TO: ALL CHRYSLER AND DODGE DEALERS
FROM: SERVICE OPERATIONS
SUBJECT: RAPID RESPONSE TRANSMITTAL/SERVICE ACTION #10-006
Steering Wheel Returnability

2009 (LX) 300/300C/Charger/SRT
2009 (LC) Challenger/SRT

Figure 1- Power Steering Cooler

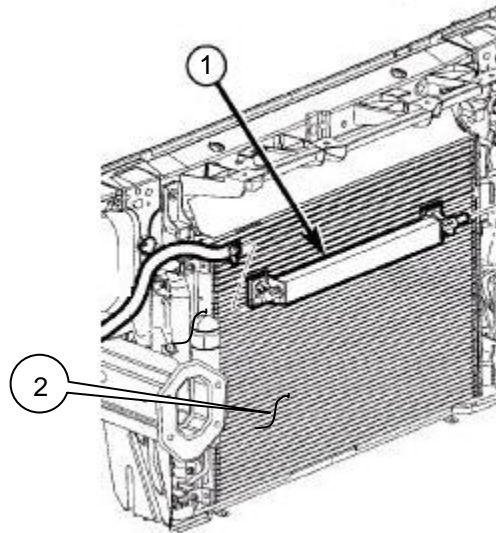
1. Remove the radiator cover.
2. Looking between the radiator support bar and the fascia verify if there is an external power steering cooler installed on the vehicle. Was there an external power steering cooler installed (Fig.1)?
 - a. **NO** – Proceed to the repair procedure.
 - b. **YES** – Install radiator cover and return the vehicle to dealer inventory or the customer.

Figure 2- Baffle (Right Side Shown)

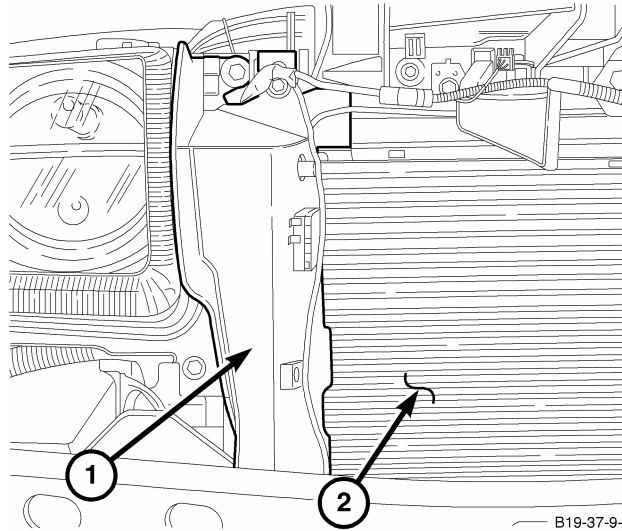
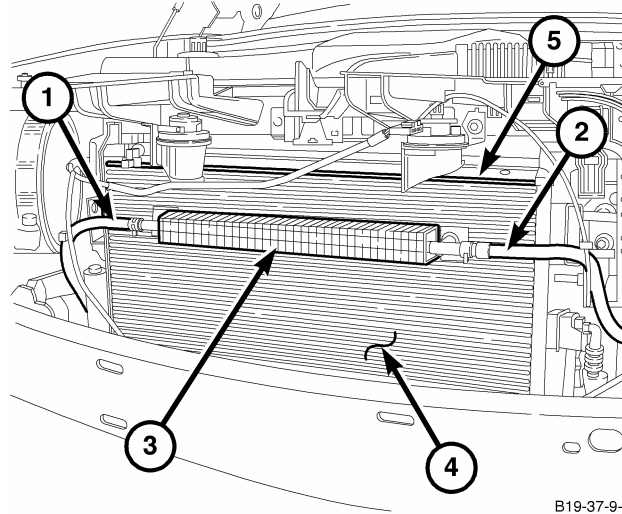
5. Remove the left and right cooler baffles (Fig.2).

21. For LX vehicles only: Re-install the cooler baffles on the left and right side (Fig.2).
22. For LC vehicles only: Install the Front Air Dam. Refer to the detailed removal procedures available in DealerCONNECT > TechCONNECT under: Service Info > 23 - Body > 13 - Frame and Bumpers > Bumpers > AIR DAM, Front > Installation.

Figure 4- SRT Power Steering Cooler

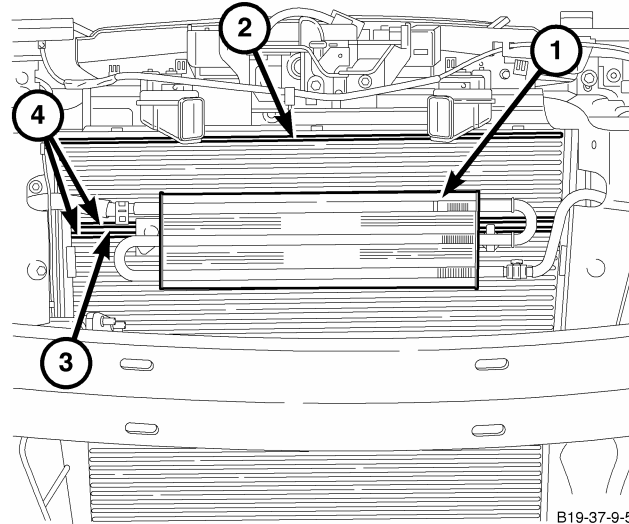
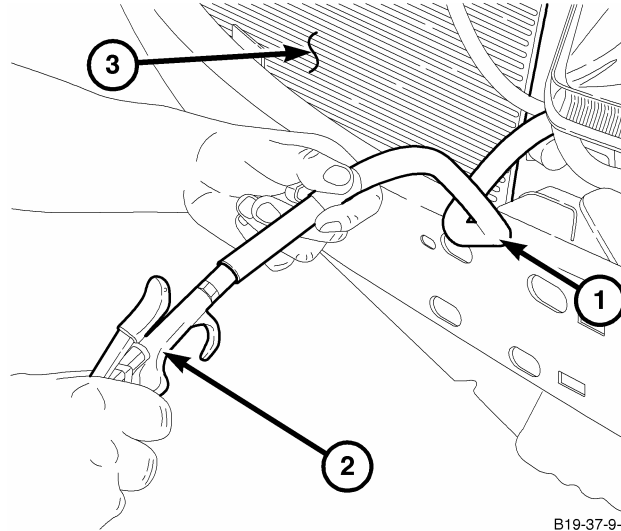
11. For SRT vehicles only: Using both cooler mounting clips, center the new power steering cooler (68017995AA) and mount between fins 11 and 12 from the top of the condenser edge (Fig.4).

Figure 6- Boot Cover

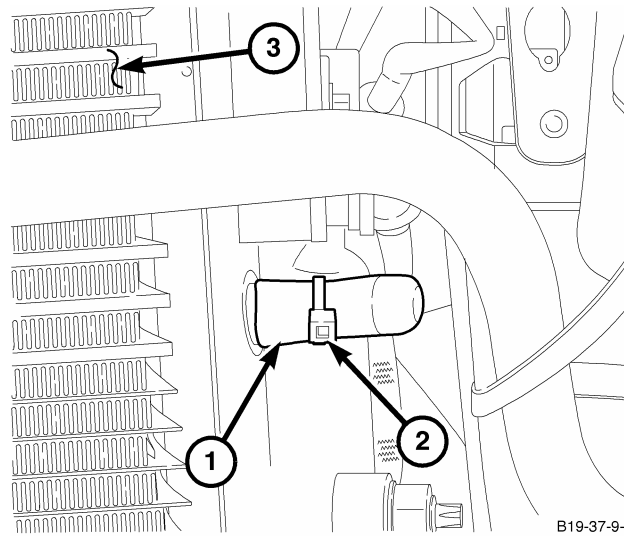
19. Install the black protective boots on the old inlet and outlet ports of the power steering cooler and secure them with zip ties as shown in (Fig.6).
